**LAWRENCE HISTORIC RESOURCES COMMISSION**  
**ITEM NO. 3: DR-12-185-11**  
**STAFF REPORT**

**DR-12-185-11** 900 New Hampshire St; New Construction; Certified Local Government Review, Certificate of Appropriateness Review, and Downtown Urban Conservation Overlay District Review. The property is in the environs of Lawrence's Downtown Historic District and the North Rhode Island Historic District, National Register of Historic Places and within the Downtown Urban Conservation Overlay District. It is also in the environs of the Shalor Eldridge Residence (945 Rhode Island), Register of Historic Kansas Places and the Social Service League (905-907 Rhode Island), Lawrence Register of Historic Places. Submitted by Micah Kimball of Treanor Architects for 9<sup>th</sup> & New Hampshire LLC, property owner of record.

# Alley Concerns

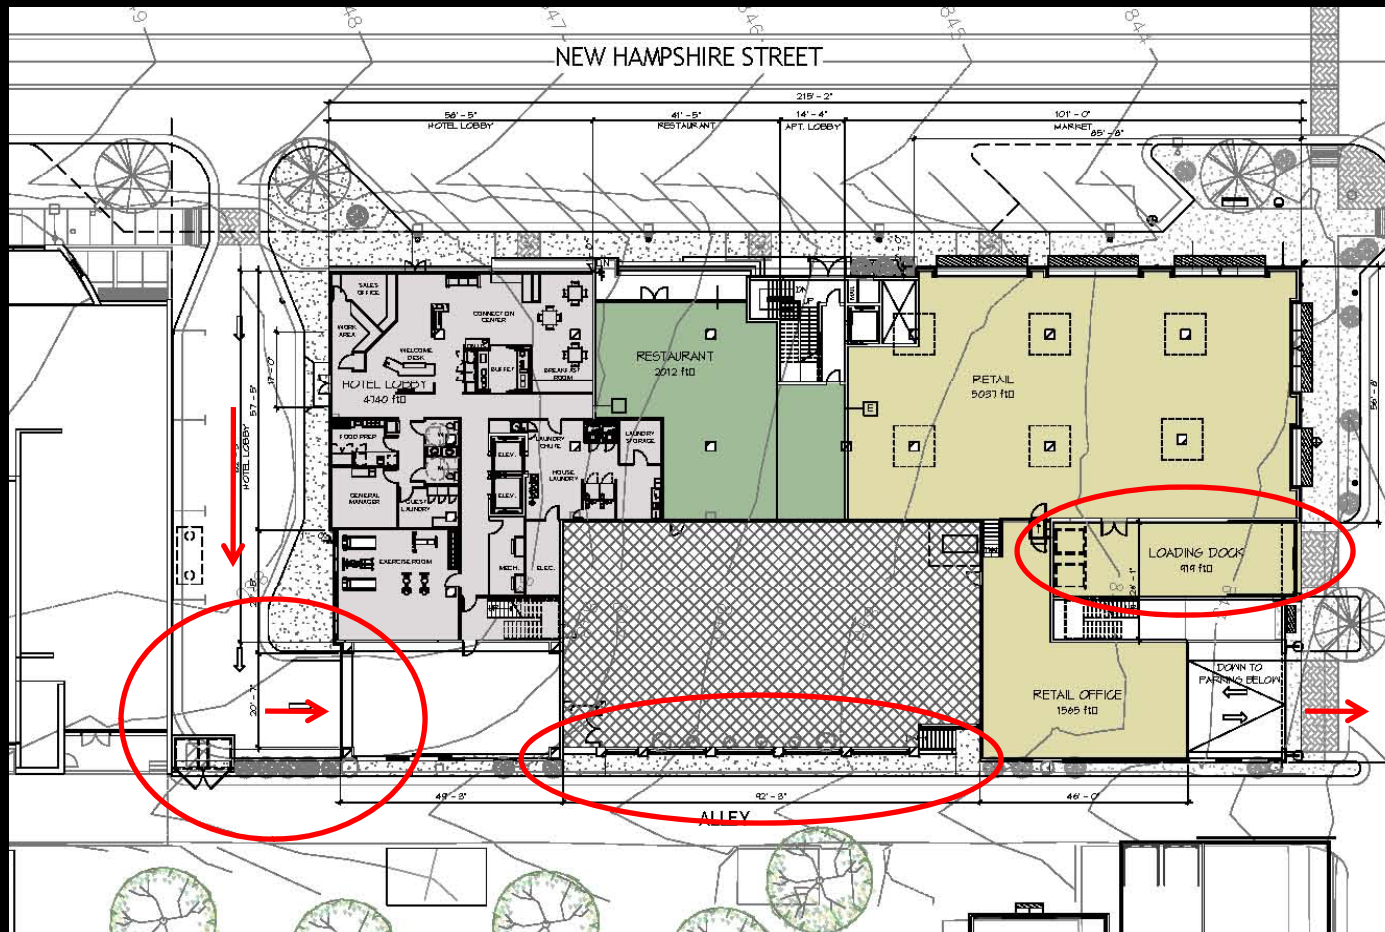
- Too much Traffic
- Width is too small
- Head lights in windows
- Courtyard at grade and open
- Articulated Façade
- Do not create a canyon

- Revising the parking garage to keep thru traffic on site
- Loading dock to decrease truck traffic for market
- Reducing the building foot print to add two feet to the alley width

# Site Plan

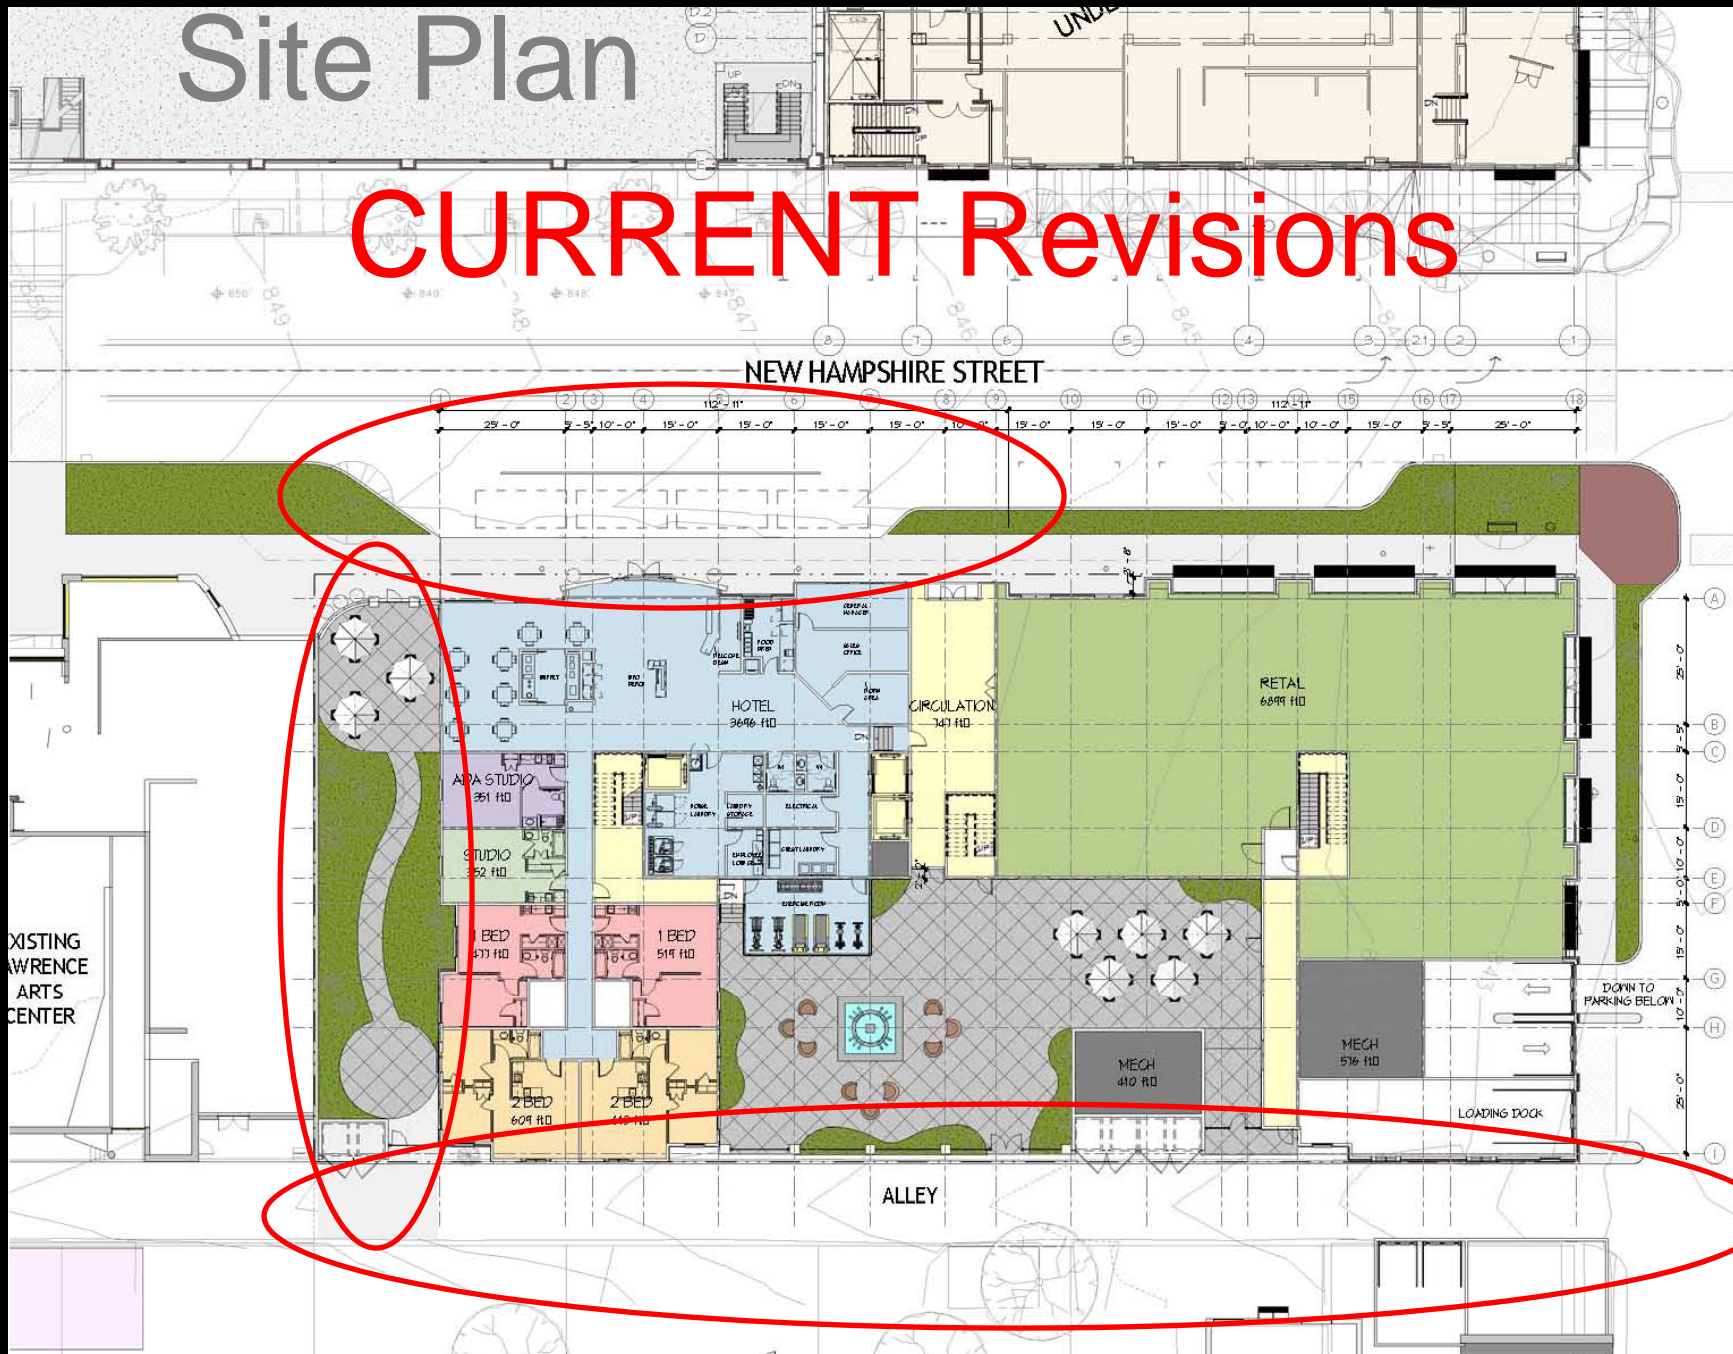
## CURRENT Revisions

Courtyard at Alley

Reduced by 10 additional feet to 52'

# CURRENT NH ELEVATION

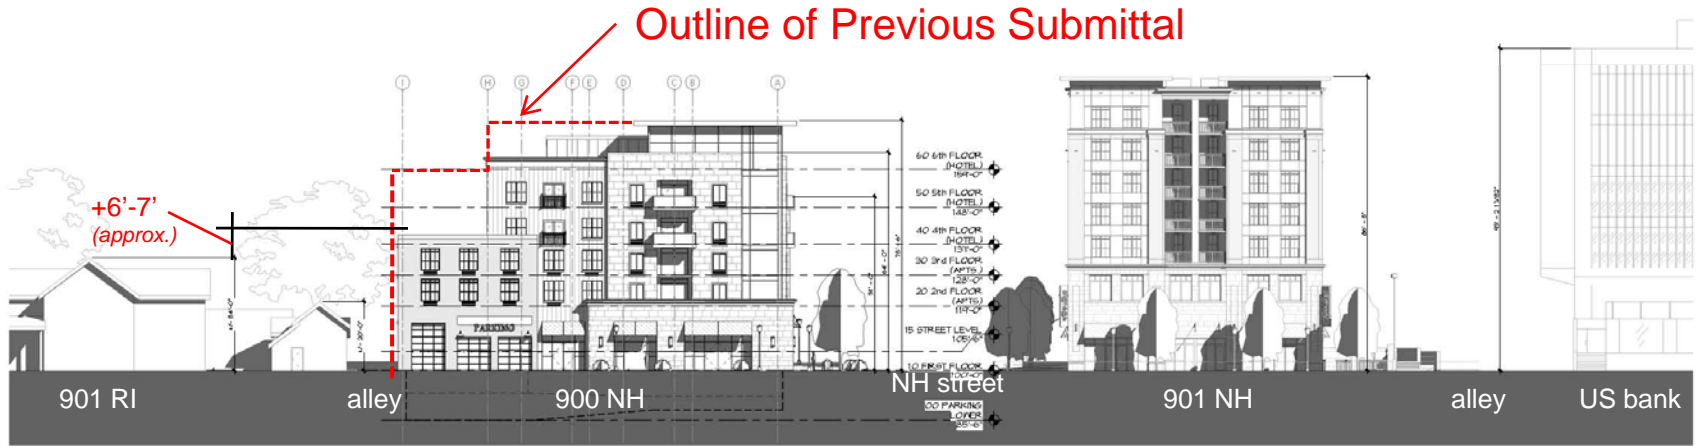
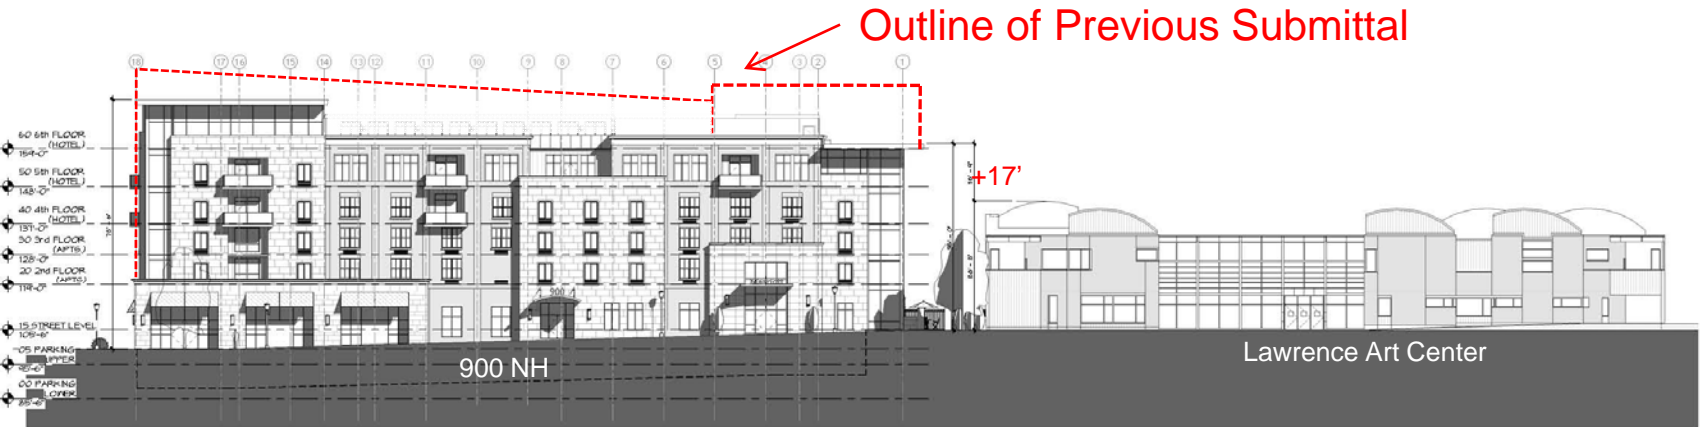
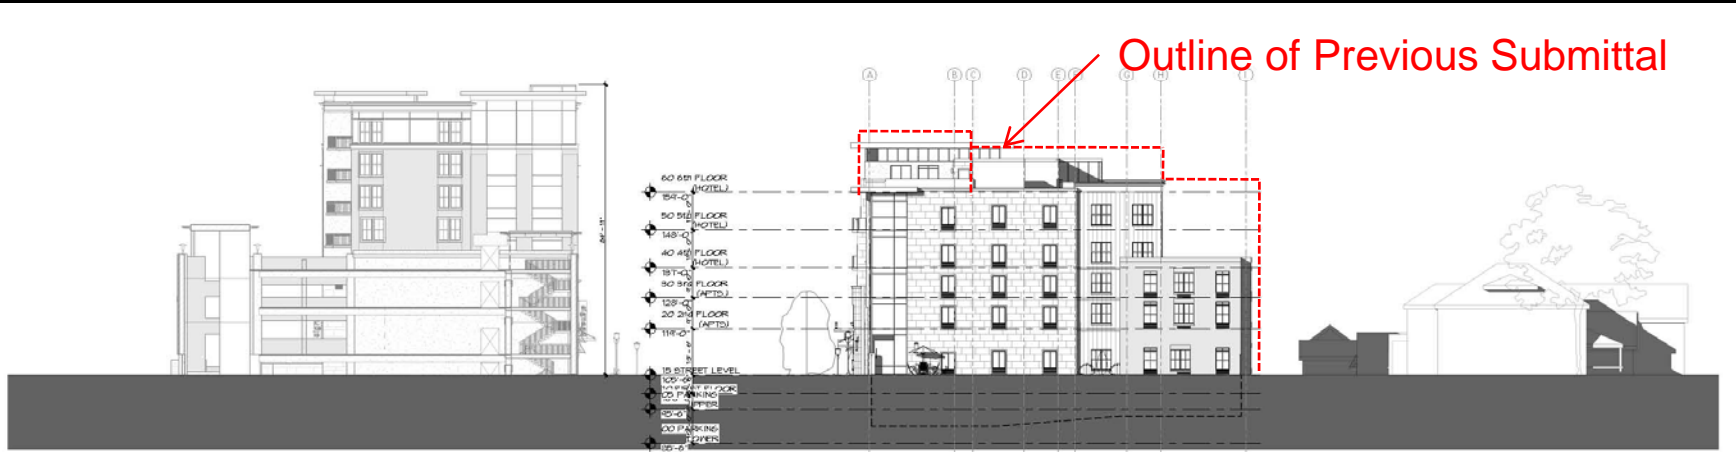
- Revised elevations.
- Revised massing into smaller bays.
- Provided more verticality of building materials and patterns.

Revised (REDUCED) New Hampshire Street Elevation: 12.6.2011

- Revised the Ninth Street and New Hampshire Street elevations
- Revised massing into smaller bays to provide a rhythm that is more compatible with downtown streetscape
- Provided more verticality of building materials and patterns per staff's recommendation.
- Recessed courtyard along alley to create open space
- Located highest portion of the building on the hard corner per Downtown Design Guidelines.
